9354 DOGWOOD RIDGE DR

CONDITIONS OF IMPROVEMENT PERMIT

Permit Number: 2781B

JOB LOCATION ADDRESS: 9354 DOGWOOD RIDGE
PROPERTY OWNER: CLAY HUCKS
BUILDING CONTRACTOR: CLAY HUCKS
SUBDIVISION NAME: COUNTRY HILLS, LOT 1A
AUTHORIZATION ISSUED BY: Charles Welch PS DATE: 2-10-99
DEHNR AUTHORIZED AGENT

PROPOSED PLOT PLAN

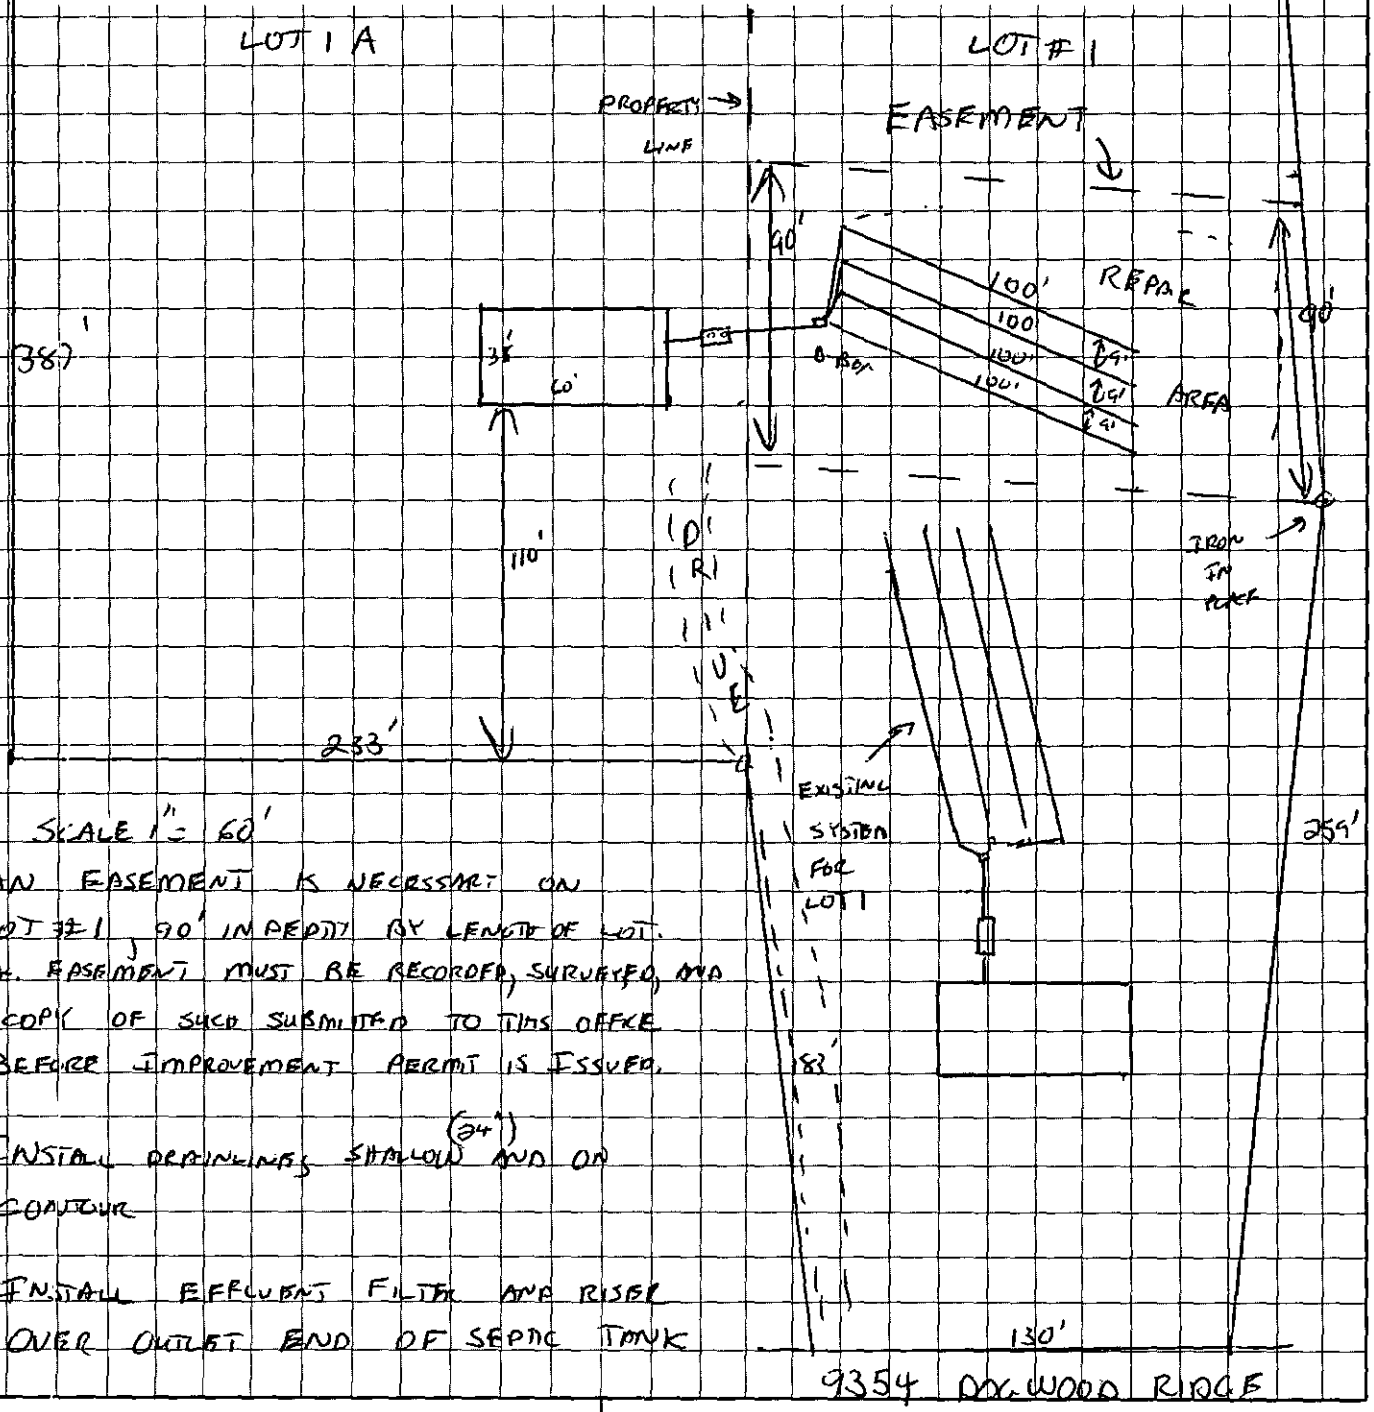
(1) AN EASEMENT IS NECESSARY ON LOT #1, 90' IN WIDTH BY LENGTH OF LOT. B. EASEMENT MUST BE RECORDED, SURVEYED, AND COPY OF SUCH SUBMITTED TO THIS OFFICE BEFORE IMPROVEMENT PERMIT IS ISSUED.

(2) INSTALL DRAINLINES SHALLOW (24") AND ON CONTOUR

(3) INSTALL EFFLUENT FILTER AND RISER OVER OUTLET END OF SEPTIC TANK

PROPOSED PLOT PLAN

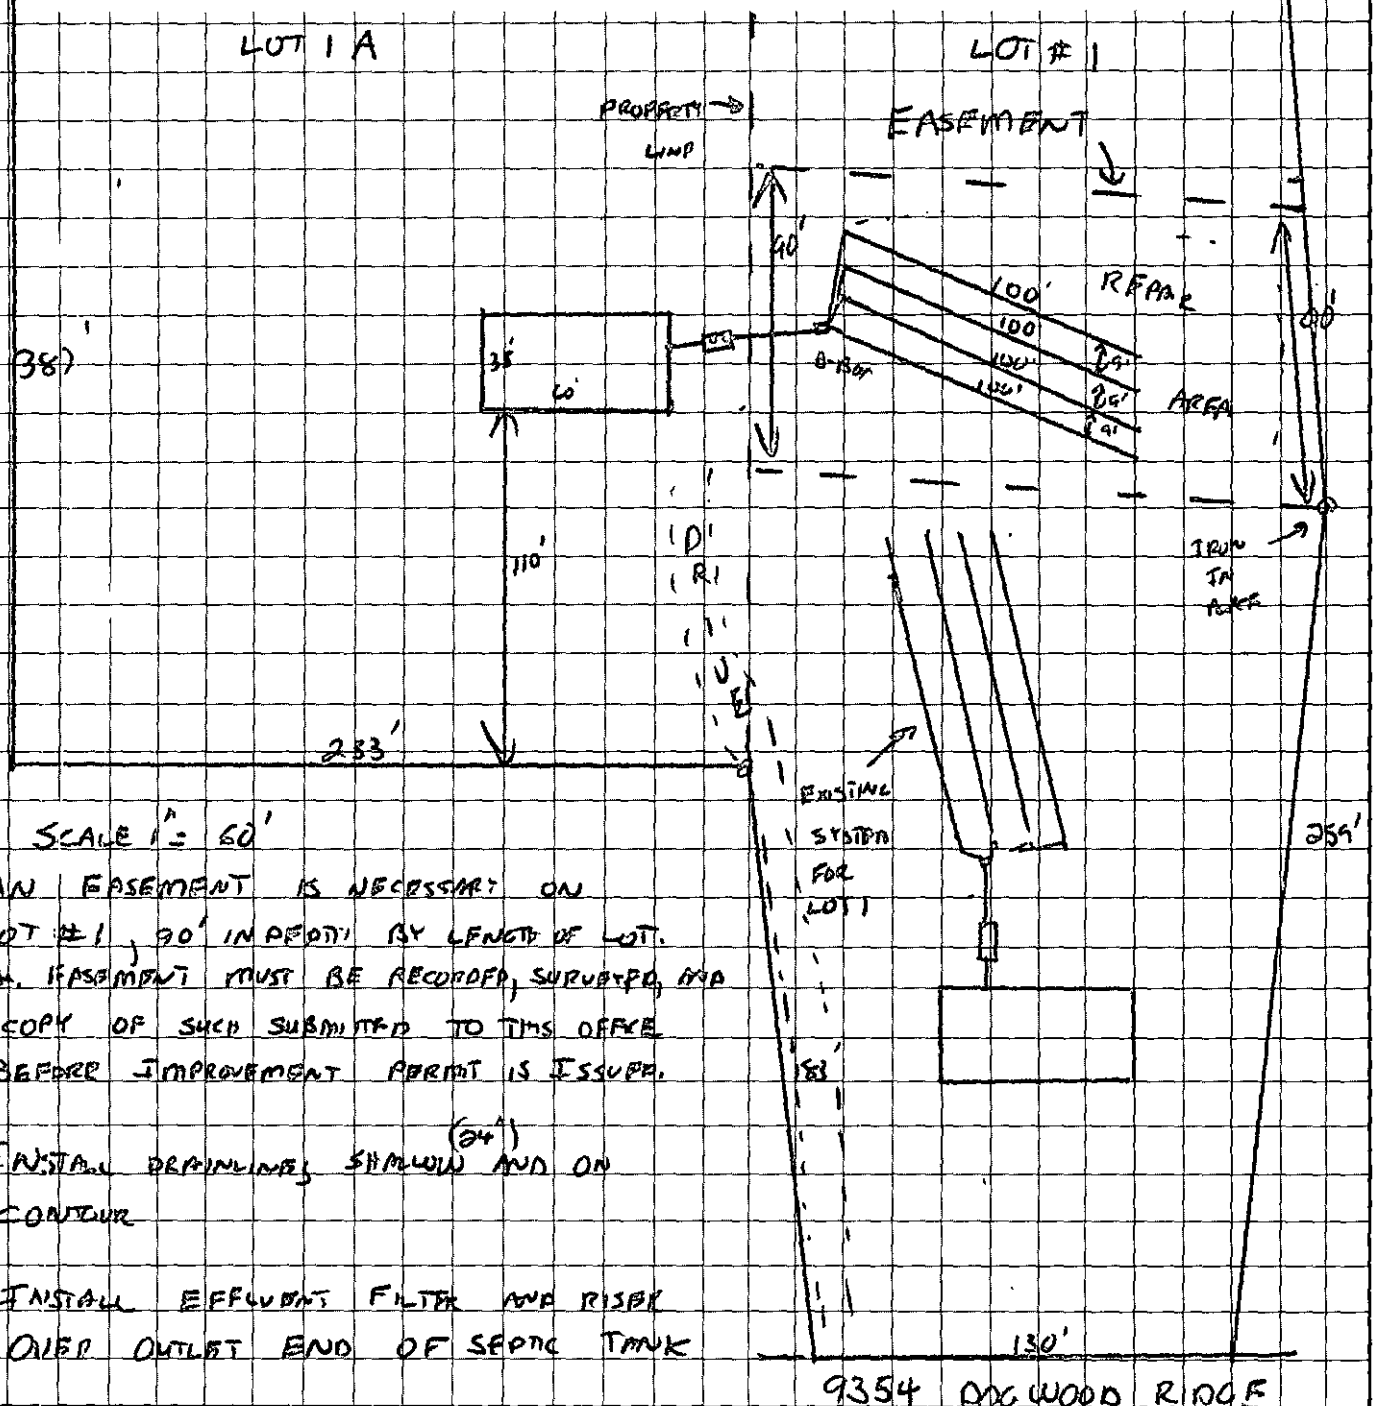
(1) AN EASEMENT IS NECESSARY ON LOT #1, 30' IN WIDTH BY LENGTH OF LOT. EASEMENT MUST BE RECORDED, SURVEYED, AND COPY OF SUCH SUBMITTED TO THIS OFFICE BEFORE IMPROVEMENT PERMIT IS ISSUED.

(2) INSTALL DRAINLINES, SHALLOW (24") AND ON CONTOUR

(3) INSTALL EFFLUENT FILTER AND RISER OVER OUTLET END OF SEPTIC TANK

PROPOSED PLOT PLAN

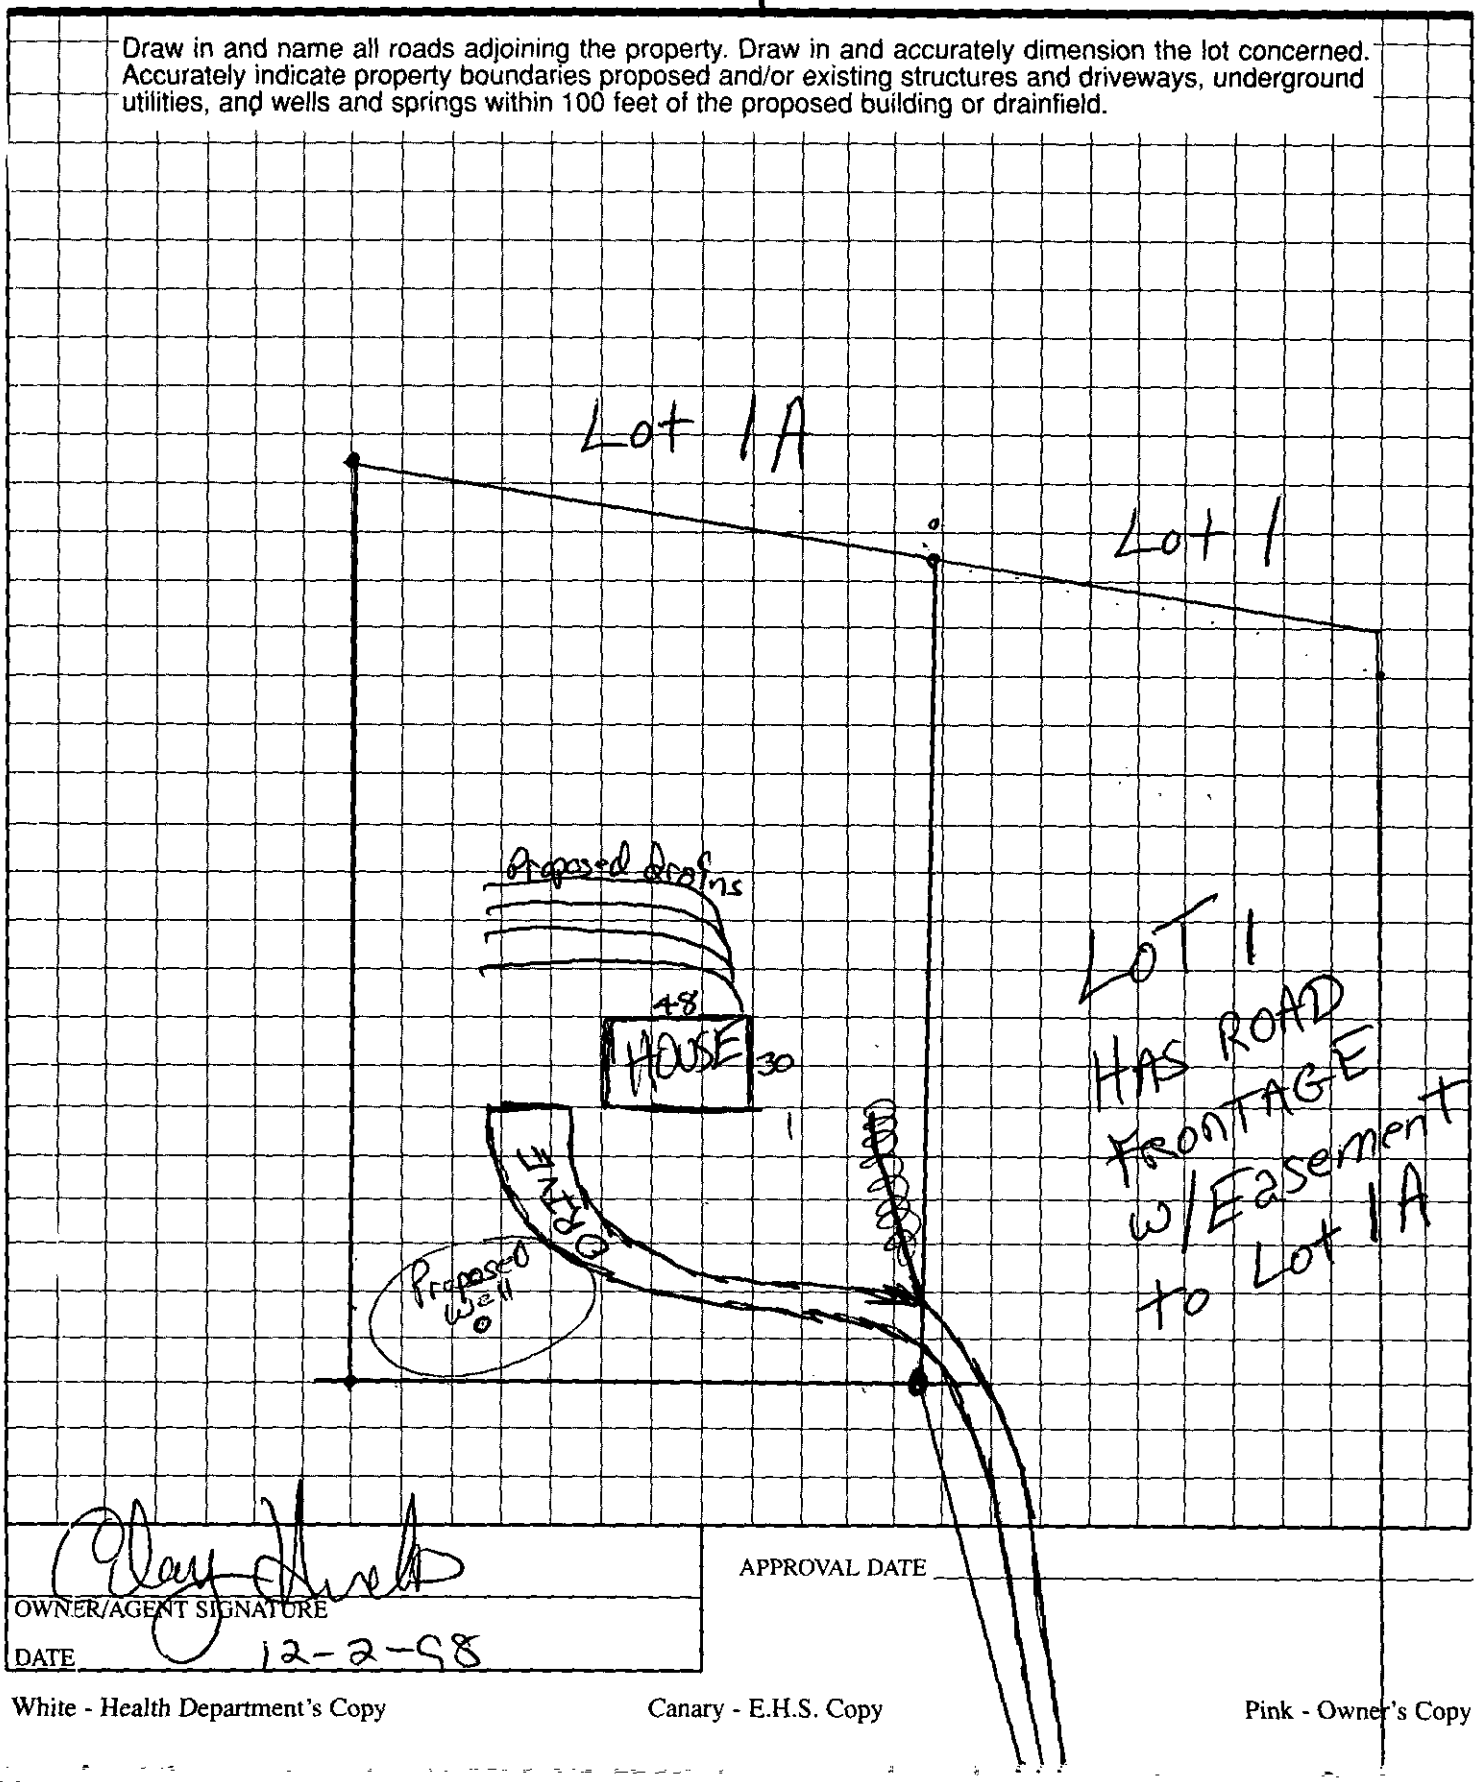
Receipt of your Application for Improvement Permit for the above referenced property is acknowledged. A soil evaluation and a site visit have been conducted. The results of the evaluation indicated that the site is **UNSUITABLE** under Rules .1941 **SOIL CHARACTERISTICS (MORPHOLOGY),** .1943 **SOIL DEPTH,** and .1945 **AVAILABLE SPACE.** For these reasons your Application for Improvement Permit is denied. A possible way to develop the site exists under Rule .1948(d), which reads as follows:
